Land at Bird in Eye Farm
South of Bird in Eye Hill
Uckfield

TRANSPORT ASSESSMENT SECOND ADDENDUM

Planning Reference: WD/2021/2198/MAO

MT/5330/TA2A.2
September 2022

TITLE
Proposed Improvements
Framfield Road
Sheet 1 of 2

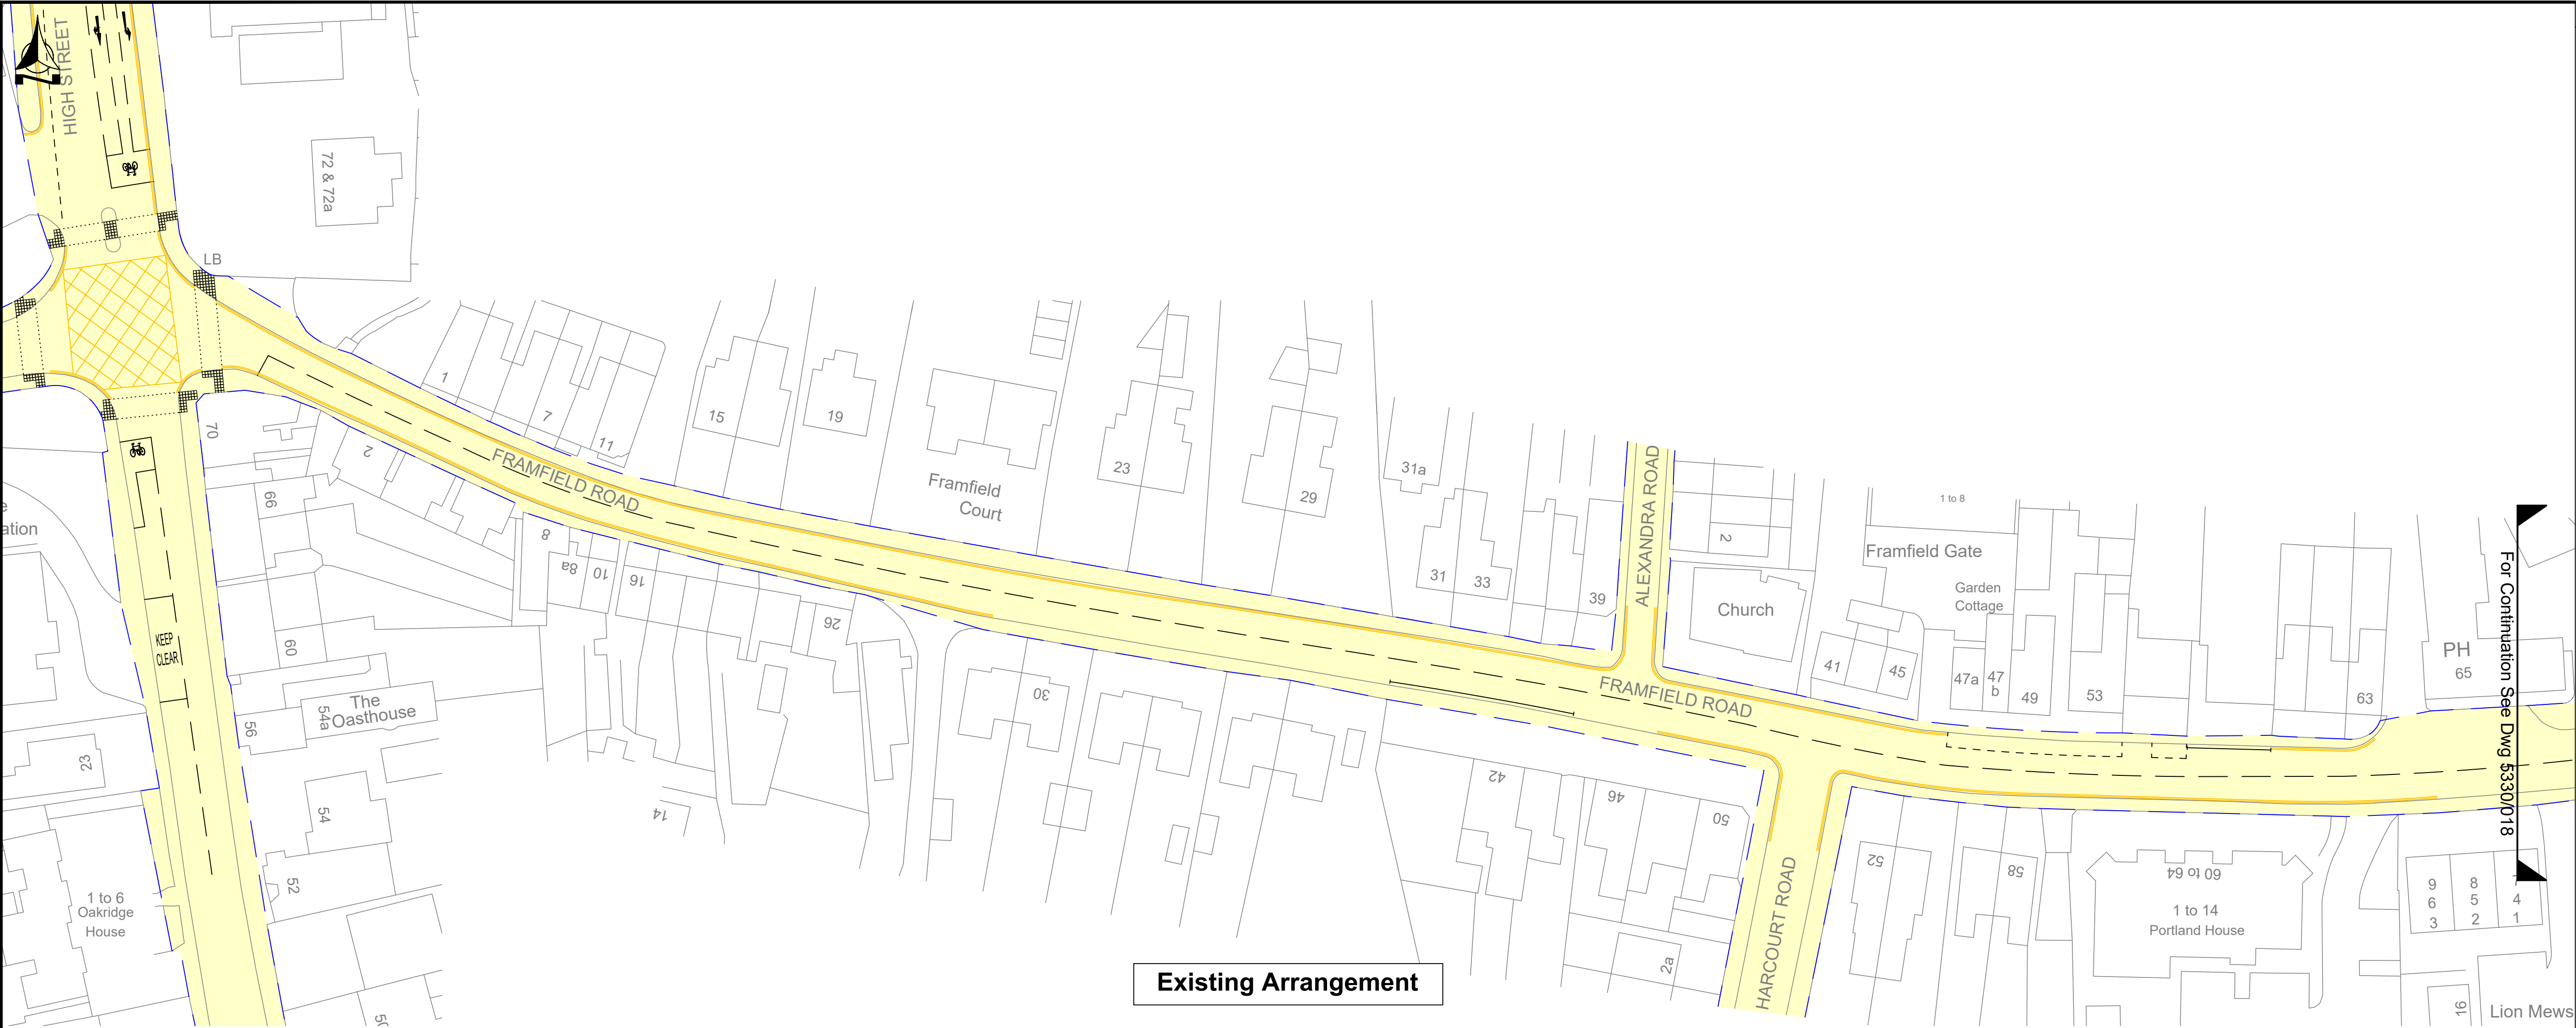
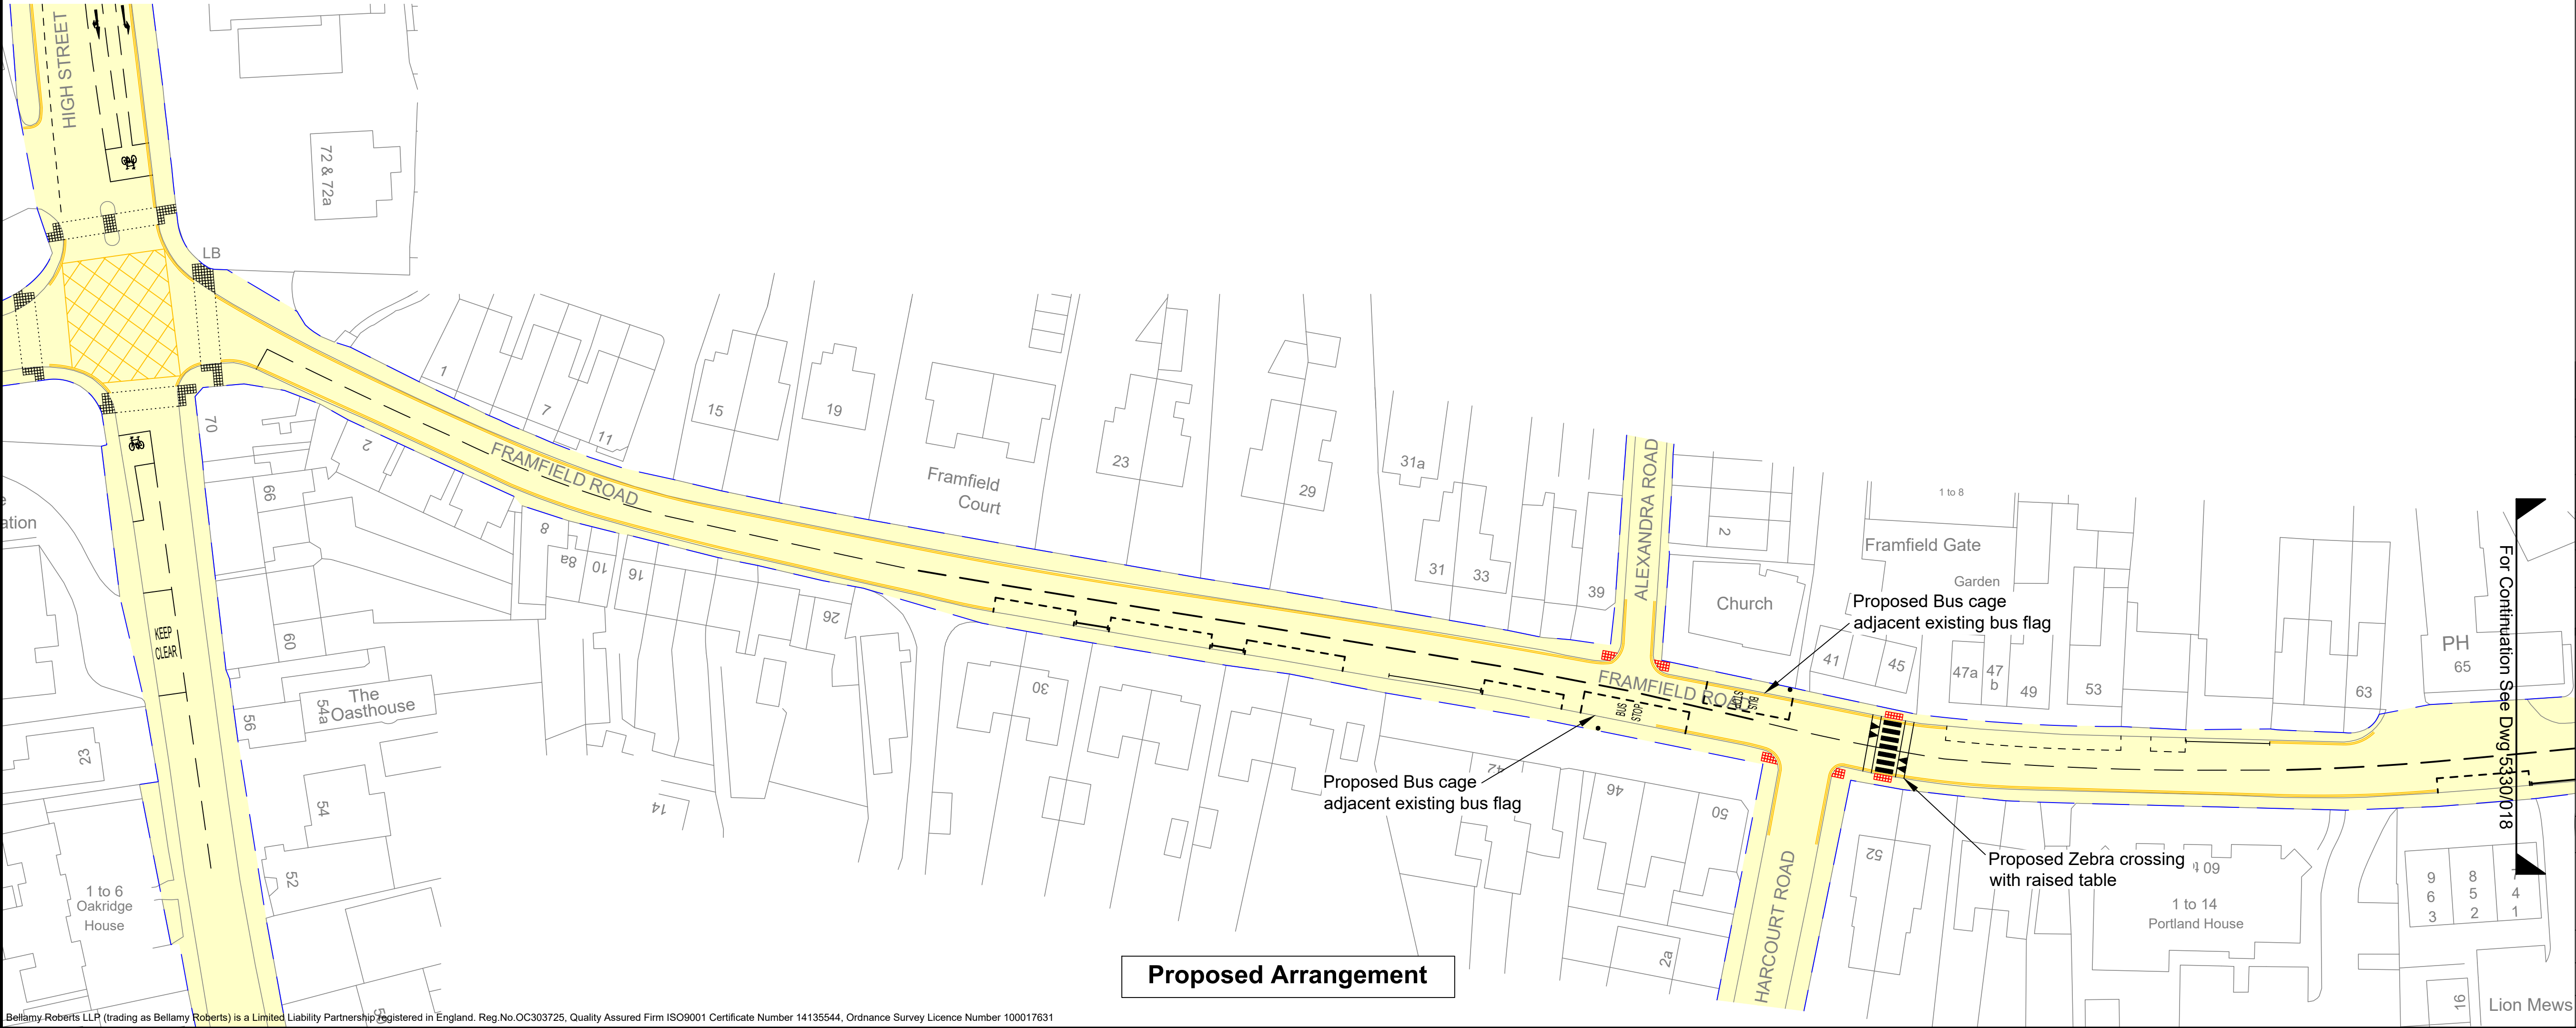
- 2.31** Comments on the proposed parking improvements to Framfield Road have been received from the ESCC Traffic and Safety Team, specifically with regard to the improvements set out on drawing 5330/017 Rev. E.

The parking scheme on Framfield Road has received comments from the Traffic and Safety Team in relation to the build-outs: The series of build outs proposed on Framfield Road do not appear to form part of the audit (first) and do not appear to serve any useful purpose? At the same width as the parking bays, they offer no contribution in terms of traffic calming and as there is a bollard central to each one, they do not aid crossing movements. As such, an alternative proposal in Framfield Road may offer more value to assist pedestrians crossing. It is noted that plan 5330/017 rev E shows an uncontrolled crossing with dropped kerbs and tactile paving outside 52 and 45 Framfield Road. There has been a request to the Traffic and Safety team from a local Councillor for a formal crossing with suggestion for a zebra crossing in the vicinity of Harcourt Road/Alexandra Road. There may be constraints in terms of the physical requirements for a zebra, in terms of driveways, junctions and bus stop but a more formal crossing would be preferable to one that is informal.

- i) the build out opposite the former church potentially prevents a bus from stopping close to the kerbs to allow passengers to board and alight safely. Installation of bus cages here is likely to be more useful than a build out.
- ii) parking bays marked either side of 69 Framfield road leave a very narrow space for access into an undercroft access leading to a yard in which a vehicle is parked. Access is likely to be restricted to the yard area if vehicles are parked at capacity either side of the access and opposite within the shown marked bays. See extracts below. Furthermore, the build-outs are provided but it is not known the reason. DYLs are present to restrict parking around the junction Keld Avenue.

- 2.32** It was discussed and agreed with the CHA in the meeting of 24th May that the previously proposed build-out features would be removed and the improvement scheme would instead comprise a formal crossing between 45 and 52 Framfield Road and installation of bus cages to serve the existing bus stops at this location.

- 2.33** The Traffic and Safety Team has advised that this would provide more benefit than the scheme proposed previously as set out in the Transport Assessment Addendum. In this regard, drawing 5330/017 and 018 have been updated to Revision F and E respectively (see **Appendix 5**) to include the requested crossing and bus cages, and the removal of the build out features.

CLIENT	Croudace Homes Ltd.		
PROJECT	Bird in Eye, Uckfield		
TITLE	Proposed Improvements Framfield Road Sheet 2 of 2		
DRAWN BY	AM/JCB	DESIGN BY	MT
DATE	06/04/21	DRAWING No.	5330 / 018
SCALE	1:250 @ A1	REV No.	E

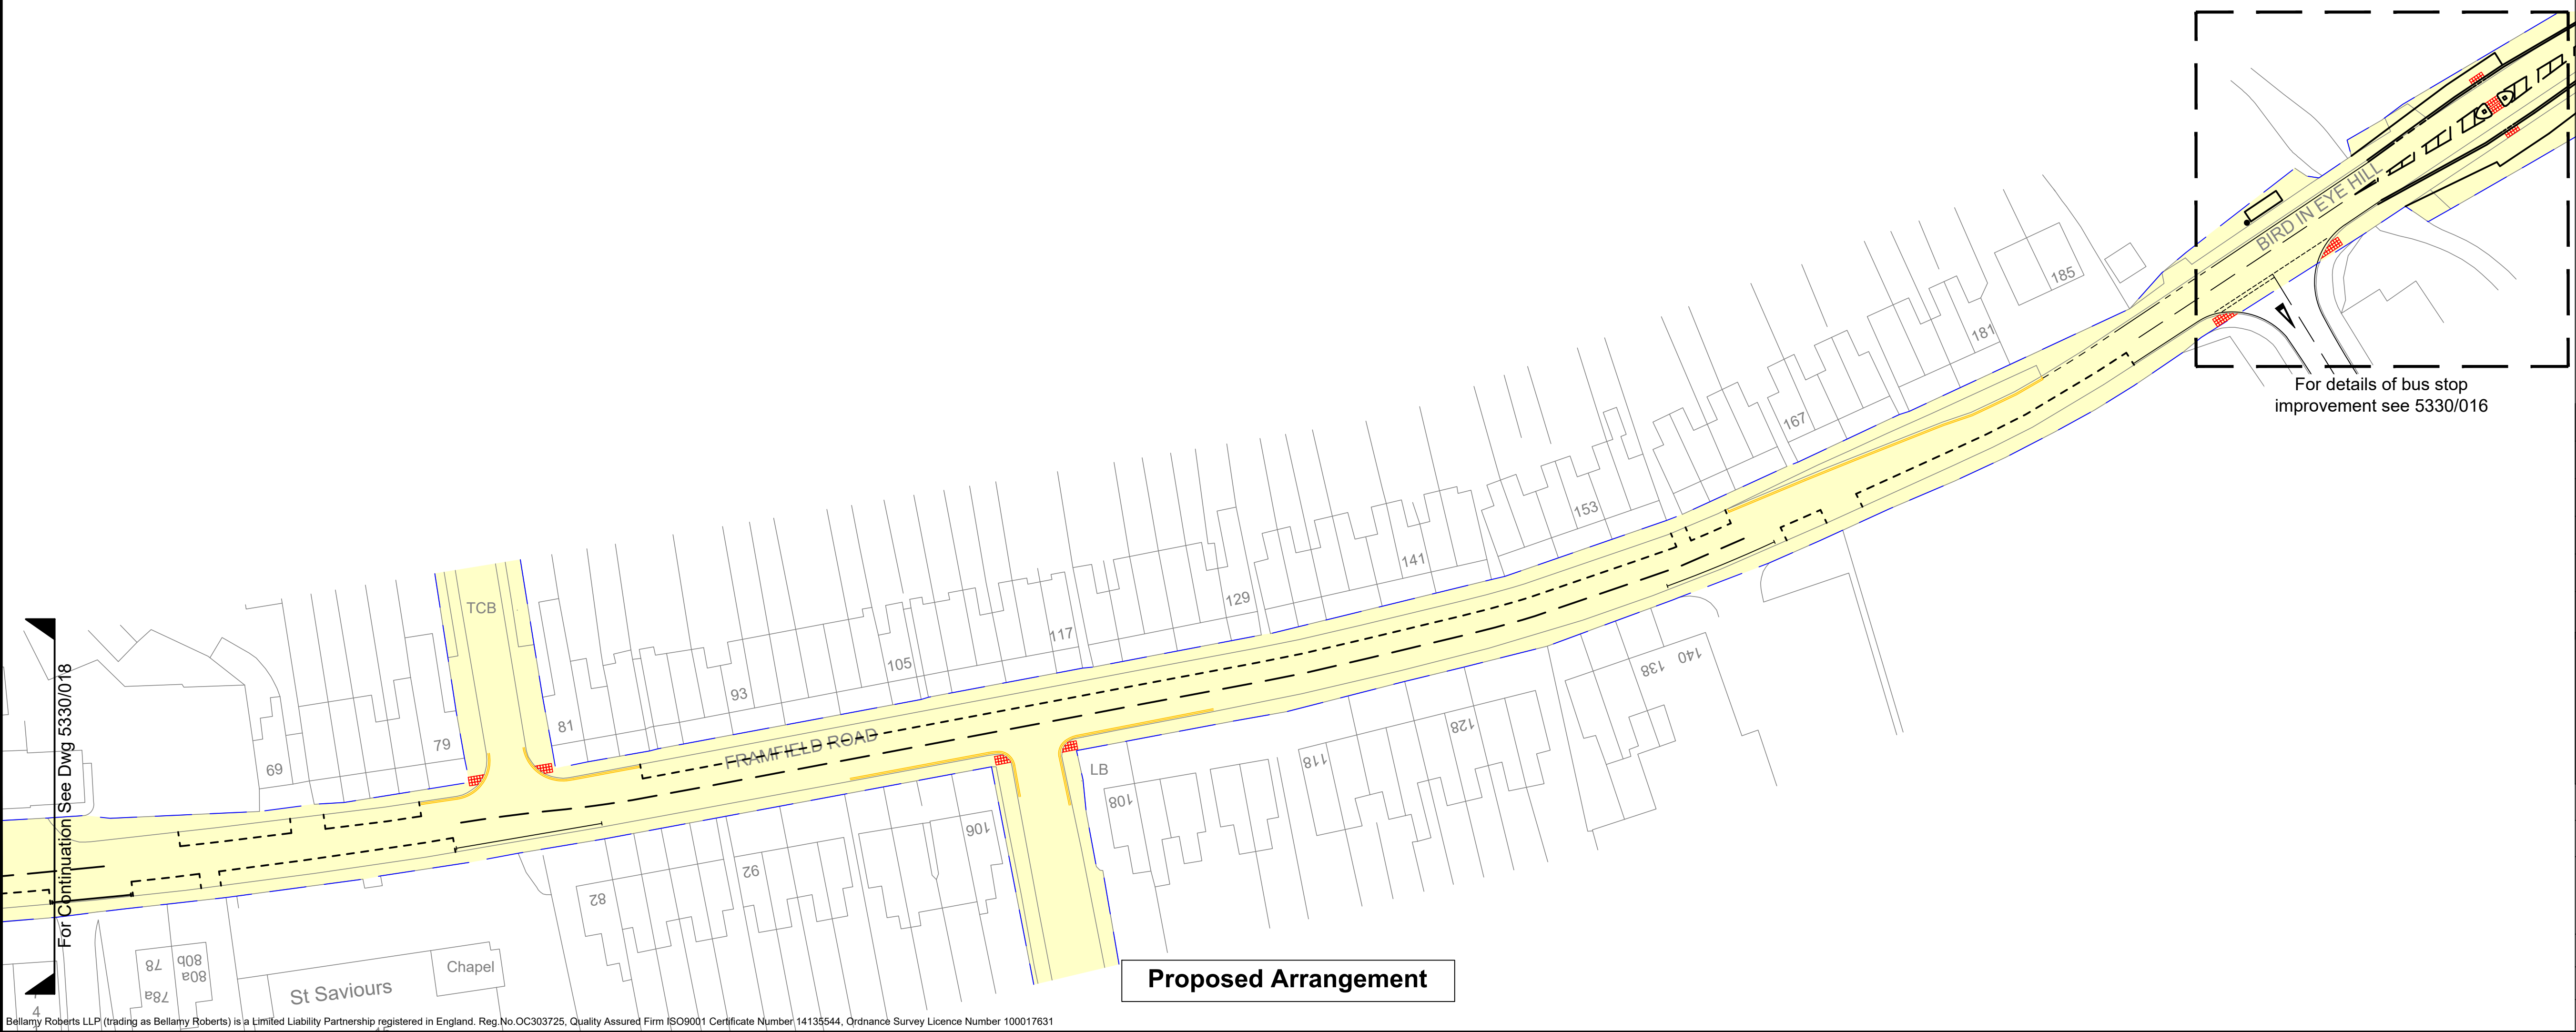
- 2.34** The CHA has commented on the proposed demarked bays for parking and noted there are no restrictions for parking where the caged areas are not shown. The proposed parking regime has sought to respect the existing dropped crossings where vehicles are unlikely to park. At these locations, no additional parking restrictions have been shown, such as double yellow lines or white access protection marking.

iii) the proposal indicates demarked bays for parking, though no restrictions for parking where the caged areas are not shown. It is presumed that the parking would still be permitted in the areas outside the marked bays unless DYLS are provided. As parking restrictions are secured through a TRO requiring public consultation, there would need to be a convincing scheme not only to the Highway Authority, but to the local residents that a parking scheme would be beneficial. I have noted the 2nd parking survey provided, undertaken on 9th February 2022. I do not understand what information the first table provides. Does the survey have a plan and photographs indicating the areas that are restricted that have been used for parking?
